UNITED STATES PATENT AND TRADEMARK OFFICE

APPLICATION NO.	FILING DATE	FIRST NAMED INVENTOR	ATTORNEY DOCKET NO.	CONFIRMATION NO.
10/774,682	02/09/2004	Thomas Rueckes	112020.129 US2 (Nan-6)	9428

Office Action Summary

DETAILED ACTION

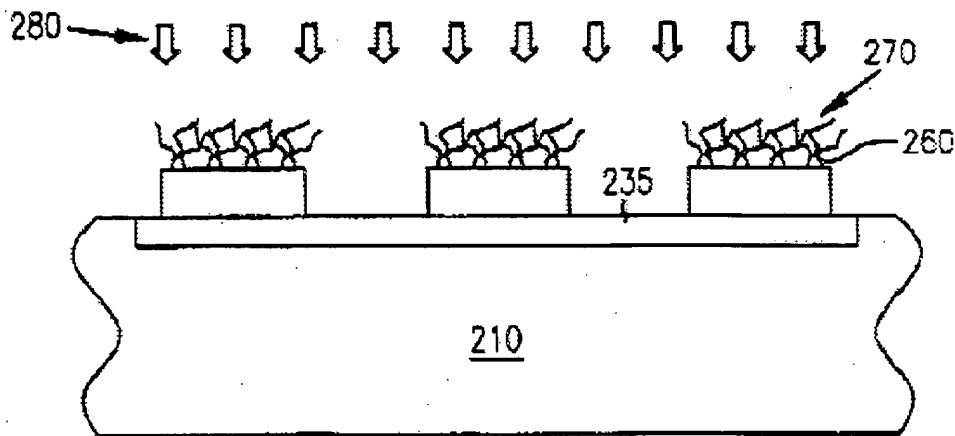
4. Claims 1-15 are rejected under 35 U.S.C. 102(e) as being anticipated by Cole et al., U.S. Patent 6,919,730 B2.

Cole discloses an assembly as claimed. See **FIGS. 1A-5** where Cole teaches the following limitations.

5. Pertaining to claim 1, Cole teaches an assembly including a substrate **210** and a conductive trace **240** disposed on the substrate, wherein the trace includes a plurality of unaligned nanotubes **260** for providing a plurality of conductive pathways along the trace.
6. Pertaining to claim 2, Cole teaches the assembly of claim 1 wherein the nanotube segments include single walled carbon nanotubes (column 1, line 35).
7. Pertaining to claim 3, Cole teaches the assembly of claim 1 wherein the nanotubes include multi-walled carbon nanotubes (front page of patent with reference to Varghese et al., "Gas Sensing Characteristics of Multi-Wall Carbon Nanotubes").
8. Pertaining to claim 4, Cole teaches the assembly of claim 1 wherein the nanotube segments have different lengths (see the explanation of figure 2D on page 95 where Rueckes discloses various minimum bistable device sizes).

9. Pertaining to claim 5, Cole teaches the assembly of claim 1 wherein the nanotubes include nanotubes having a length shorter than the length of the article (see **FIG. 2D**).
